DI19.5.1 and DI19.6.1

Walk Toronto Comments on DI19.5 Accessibility- Bloor Street Bike Lane, Shaw Street to Avenue Rd.; and DI19.6 Accessibility at Construction Sites

From: Walk Toronto (Steering Committee)

Date: April 18, 2018

Figure 1 - Vancouver side street accessible parking design allows vehicles to park on side streets close enough to the intersection for people in wheelchairs to make use of corner curb cuts. There are no conflicts with cyclists on bike lanes.

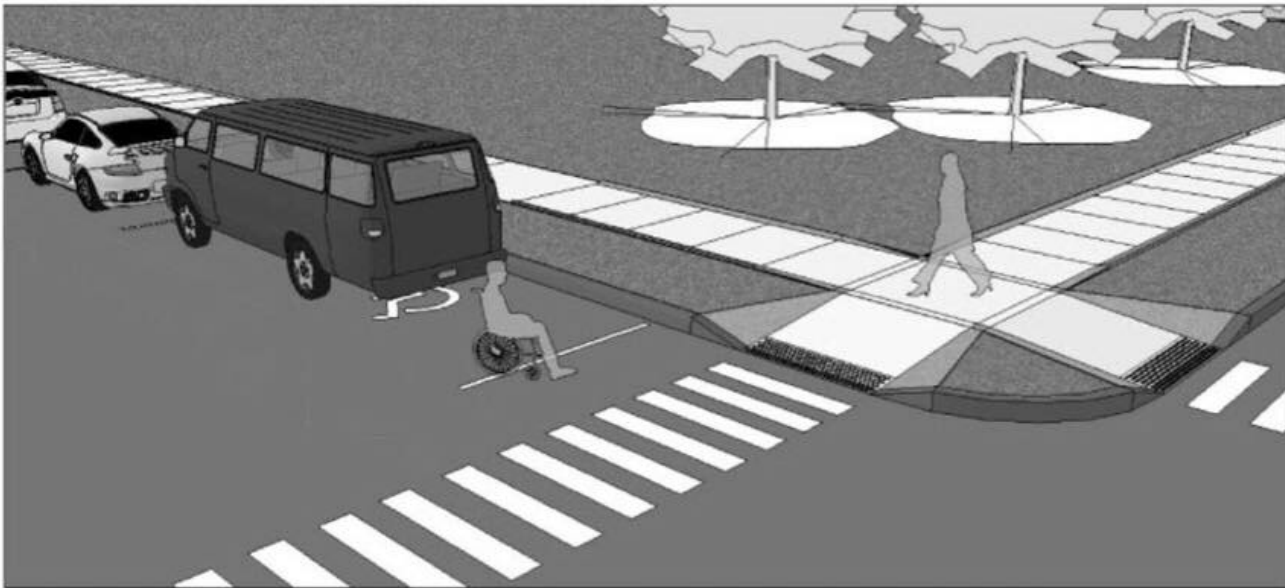
- Instead, accessible parking spaces should be created on every side street near its intersection with Bloor, using a design that is common in Vancouver. (See illustration below).

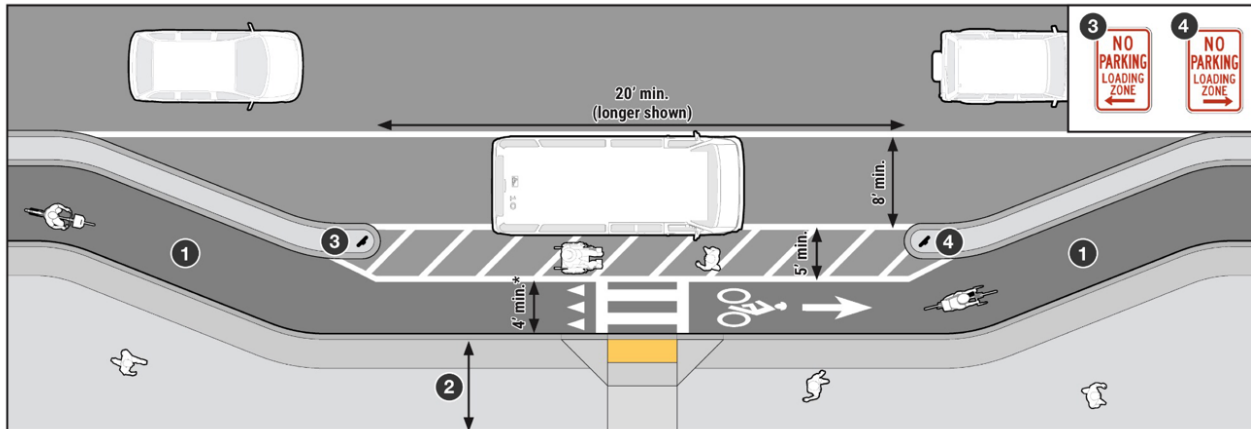
- Accessible mid-block drop-off and pick-up lay-bys should be built in locations where the need is most felt. The floating island design is safest for cyclists, as it does not create holes in the bike lane. The loading zone at Trinity-St. Paul's Church (see p. 3 of the staff presentation) has the right idea, though it lacks the conspicuous pavement markings that we like about the Massachusetts design (see below.) The alternative, a curbside design, is the most convenient for vehicle users, but should be used sparingly.
